**Change Summary:**

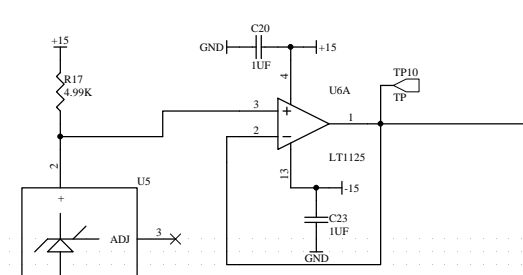
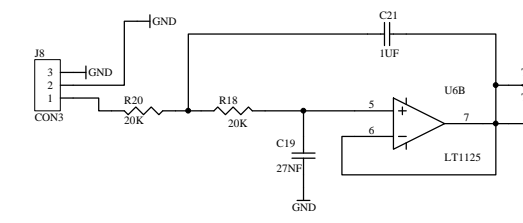
- Needs a resistor to ground (10K) on the tidal input so that it doesn't float up when not connected.
